# PD Modification Application: MM 24-1137

Development Services Department

## 1.0 APPLICATION SUMMARY

The applicant requests a Major Modification to PD 22-1387, which is approved for a 100,000 sf for self-storage facility and accessory uses. A second development option is proposed for retail uses.

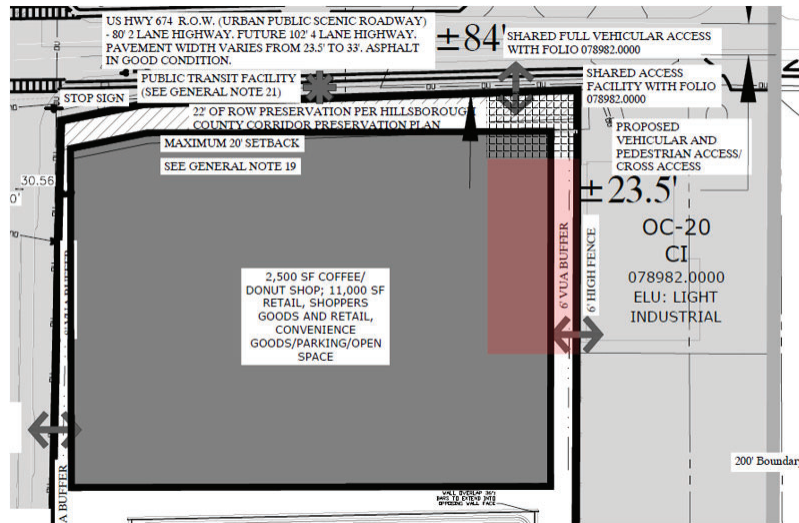
The project proposes to not meet the 2:1 setback requirement for buildings over 20 feet in height. This setback requirement is applicable to only the eastern and southern boundaries (not the front yards along the north and west). The overlay standards do not have any minimum side yard setbacks. Option A proposes a maximum height of 50 feet, resulting in a minimum 60-foot setback from the east and south. Option B proposes a maximum height of 35 feet, resulting in a minimum setback of 30 feet from the east and south. Property to the south and east is primarily vacant and approved for intensive commercial uses. Given the existing stormwater pond along the south, significant distance will still be provided. The site is not adjacent to any residential uses and the proposed heights do not exceed what is permitted in the overlay standards. Furthermore, while not required, screening will be provided along the eastern and southern boundaries (Option A to provide Type B screening, Option B to provide Type A screening).

Staff does not object to the requested waivers (see Section 7.0).

## Requirements for Certification:

1. Sheet 1 (Option A) and Sheet 2 (Option B) to remove Minimum lot size and Minimum lot width from Development Standards Table.
2. Modify the boundaries of the developable area, and remove certain parking lot and other details to ensure the plan looks like the image below; and,
3. Modify the Shared Access Facility crosshatching so that it encompasses the entire area between the SR 674 access and the relocated Access/Cross arrow along the eastern project boundary (as indicated by the red shading below).

#### LDC Section 3.23.07.H (parking location)

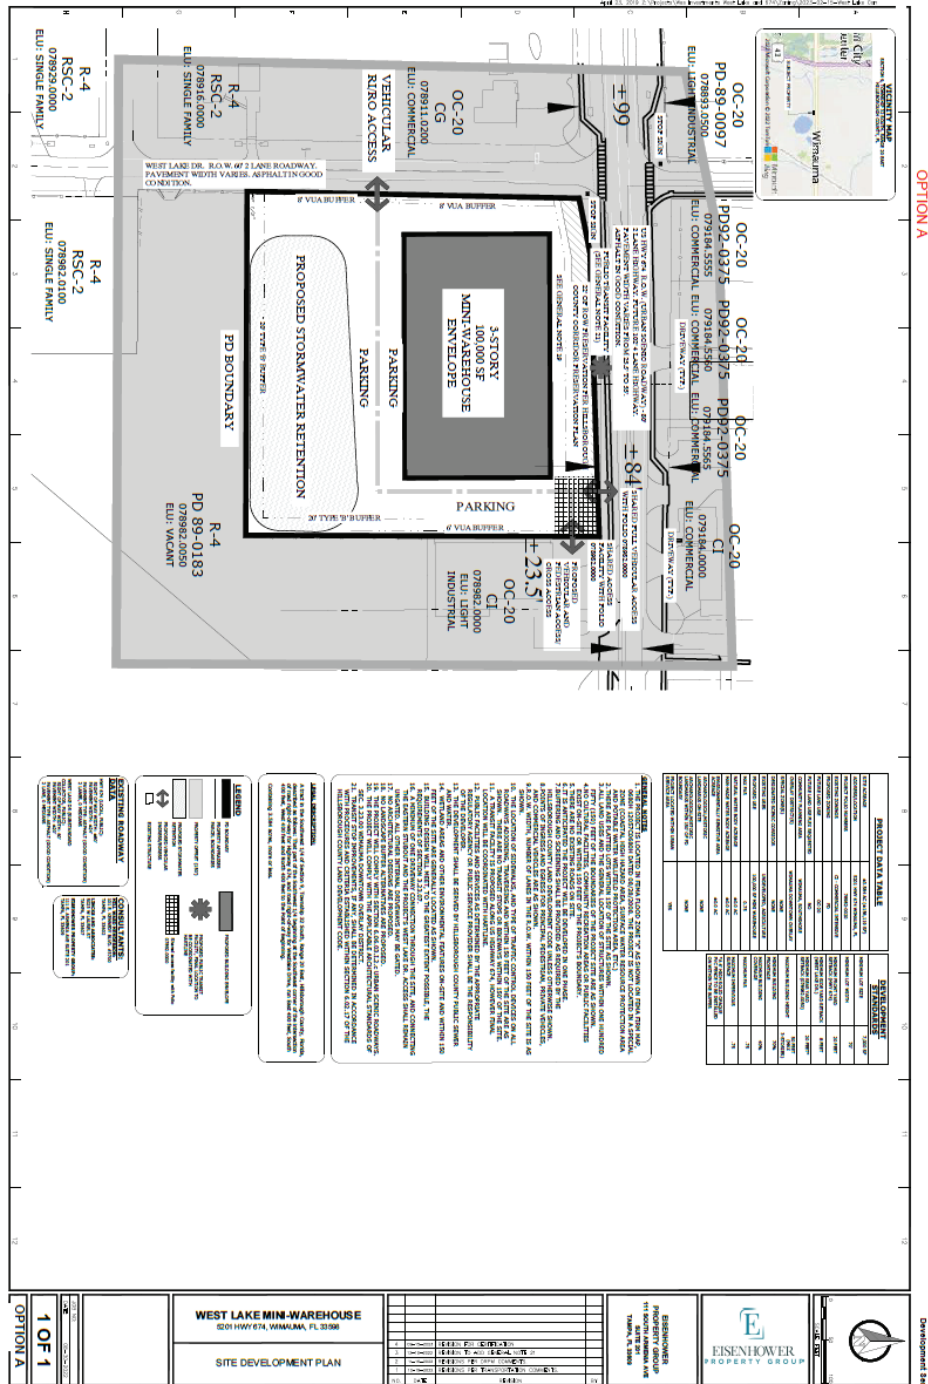
The overlay requires that project which front SR 674 place parking the front façade of the building, or within parking garages. The applicant proposes to have parallel parking available between the building and SR 675, with the primary parking area located to the rear of the building. Due to the existing stormwater pond to serve roadway improvements, a larger parking area in the rear of the building is challenging for the uses which require a higher amount of parking. The parallel parking will provide additional activity along the frontage (similar to on-street parking in traditional downtown developments). The project will comply with required tree plantings per the Urban Scenic Corridor along SR 674 (approximately 9 street trees and seven canopy trees).
